Subject: Grand Gulf Nuclear Station
Unit 1
Docket No. 50-416
License No. NPF-29
ASME Section XI Relief Request Number I-00009 Revision 2

attachments: 1. Summary of Revision 2 Changes
2. Relief Request Number I-00009 Revision 2

GRAND GULF NUCLEAR STATION
UNIT 1
RELIEF REQUEST I-00009, REVISION 2

INSERVICE INSPECTION OF PUMP CASING AND ATTACHMENT WELDS

FIGURE 1

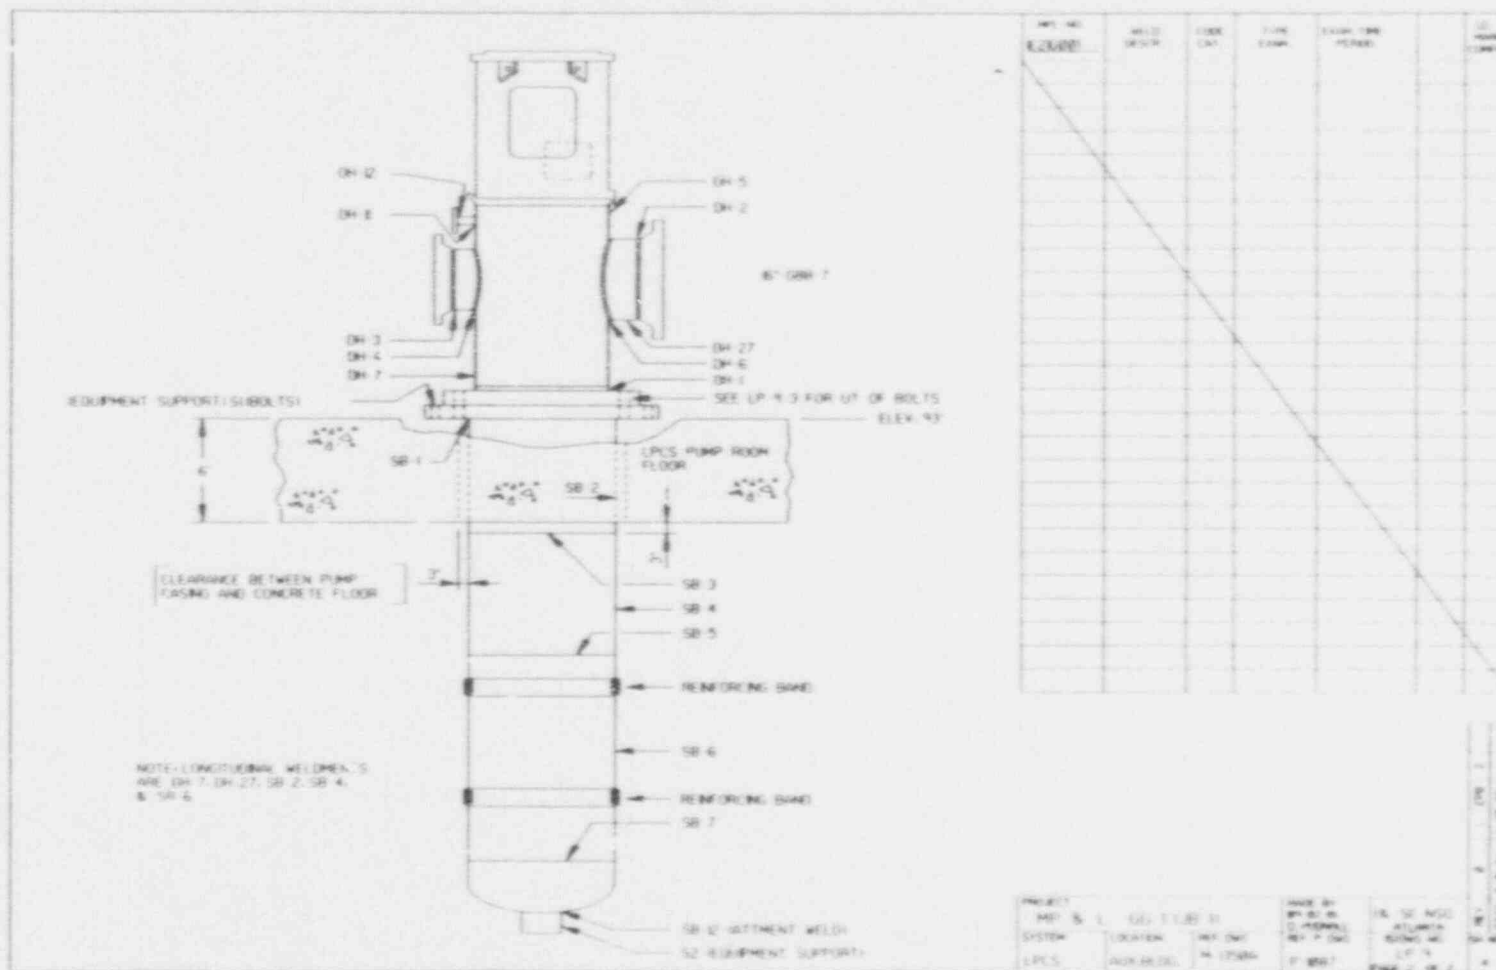
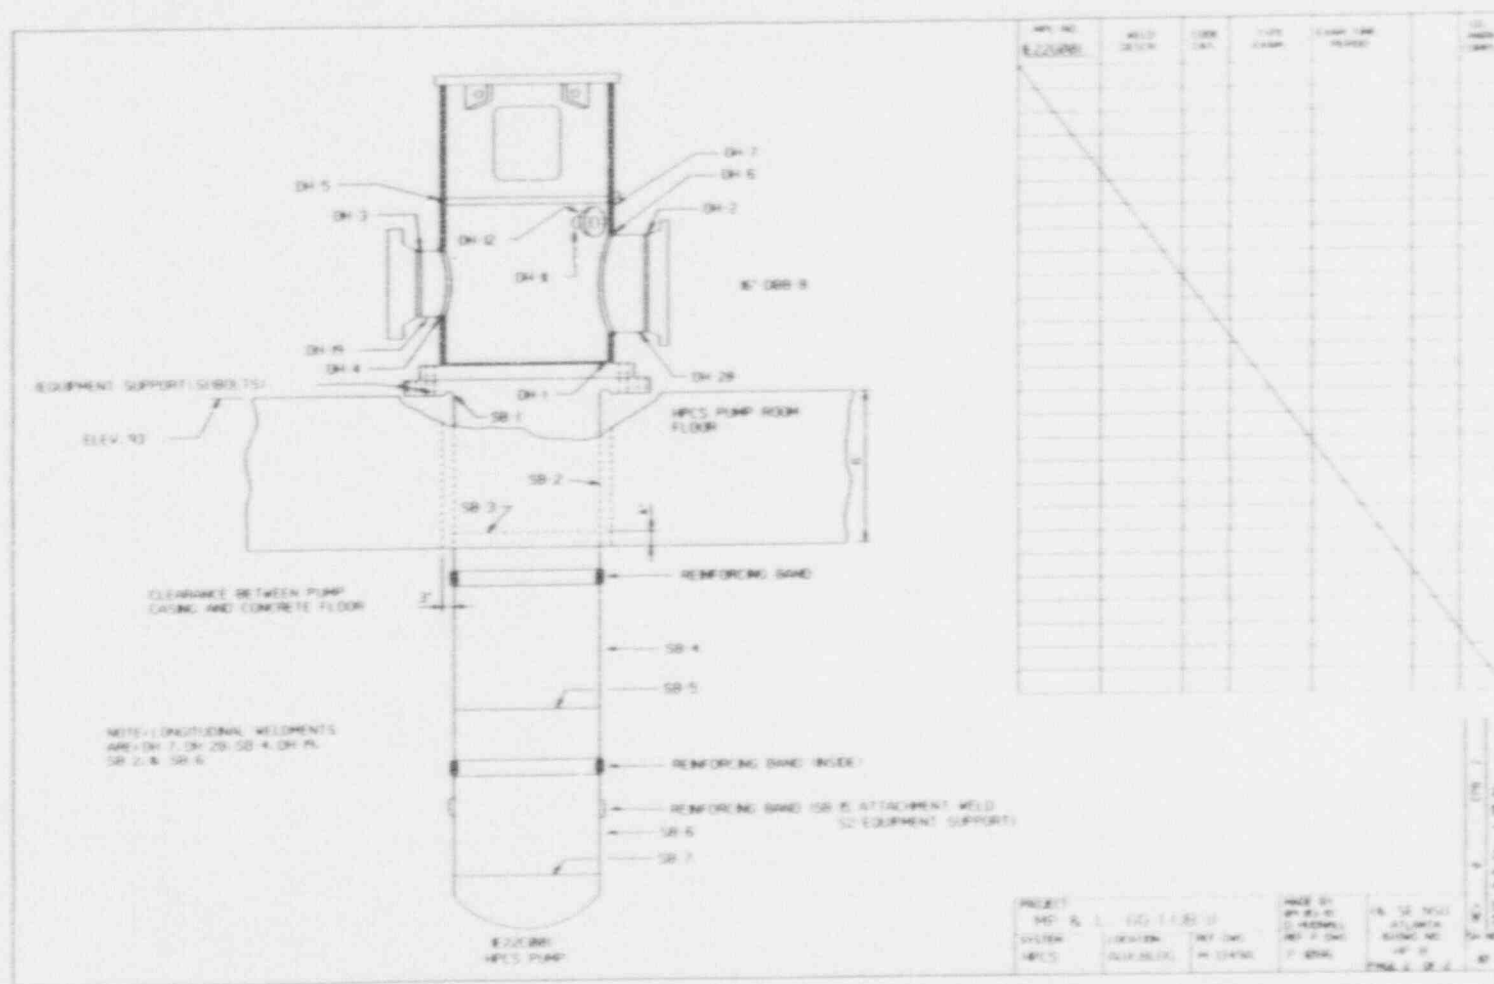
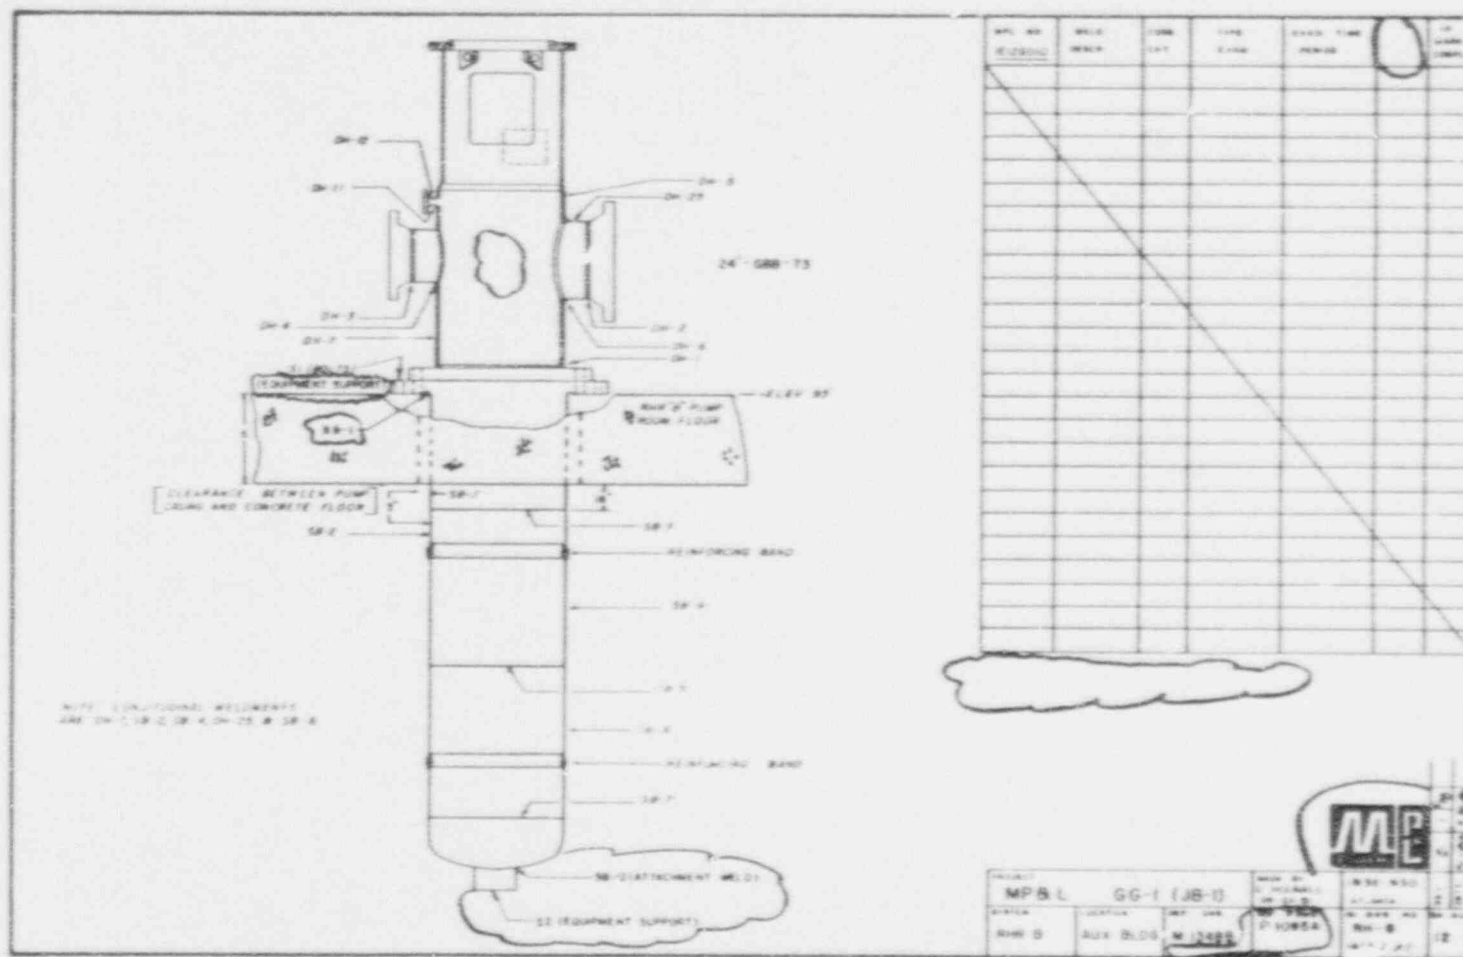
- IV. Information to support the determination that the Code requirements are impractical: Inaccessible pump casing welds are located where the concrete pump support encasement only allows a 3 inch clearance between the pump casing and the concrete encasement wall (see figure 1 for details of the design). Due to the limited accessibility, it is impractical to surface examine those portions of the welds located within the surrounding concrete pump support encasement. The 1E12C002B and 1E21C001 pumps also have a support integrally welded to the bottom exterior of the pump barrel that rests against the sump floor. The clearance between the floor and the bottom of the barrel is approximately 1 inch preventing sufficient access to perform the surface examination of the 1/2 inch of base material on each side of the attaching weld (see figure 2).

FIGURE 2

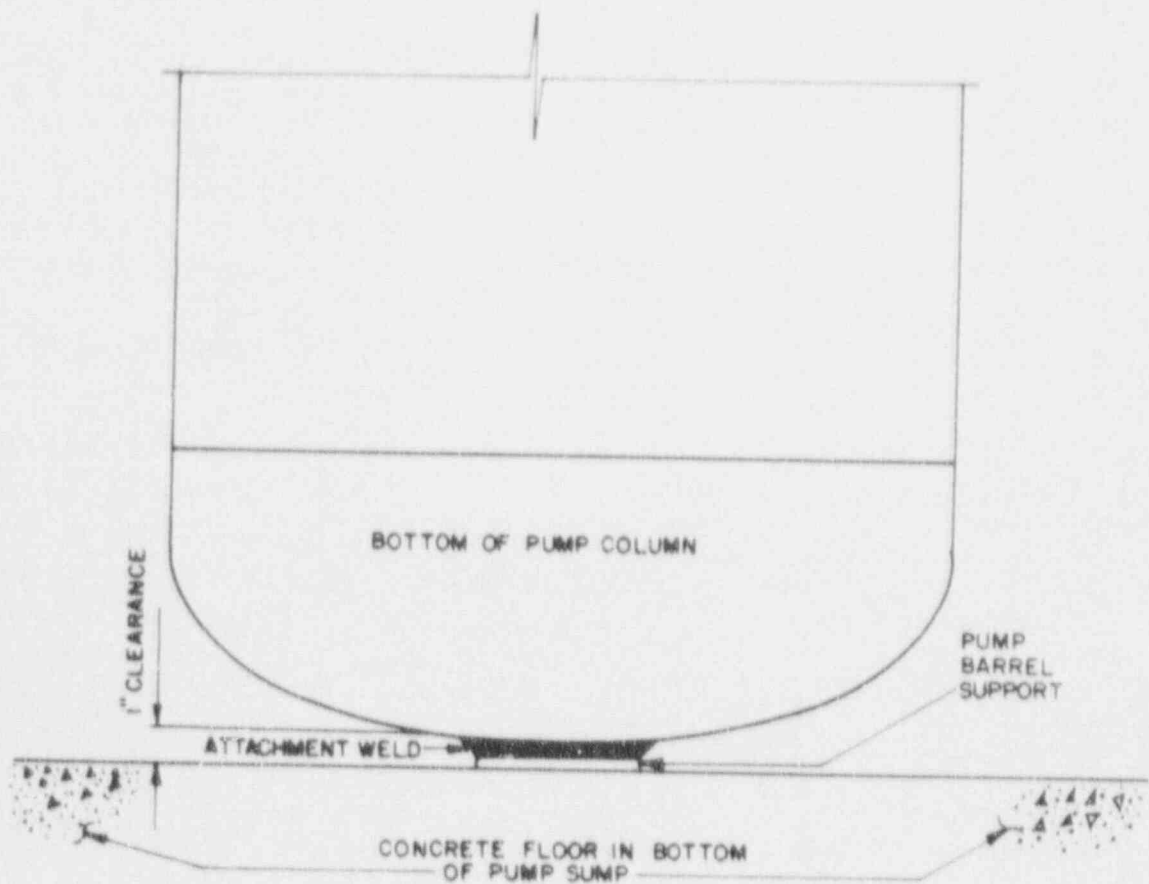
Permission is requested to exempt from inservice inspection the inaccessible portions of the pump casing welds listed on Table 1. Also permission is requested to exempt the base material associated with the support attachment welds from the surface examinations as shown in figure 2.

The staff concludes that the limited surface examination of the support-to-casing welds for the residual heat removal pump and the low pressure core spray pump will provide the necessary assurance of structural reliability because although 1/2 inch of base metal on each side of the weld cannot be examined, 100% of the weld metal will be examined. In addition, if the pumps are disassembled for maintenance, surface examinations will be completed from the internal surface. The staff also concludes that compliance with the specific requirements of Section XI would result in hardship or unusual difficulties without a compensating increase in the level of quality and safety. Therefore, relief is granted as requested.

SB-12 (see figure 2 for details of limitation)

SB-12 (see figure 2 for details of limitation)
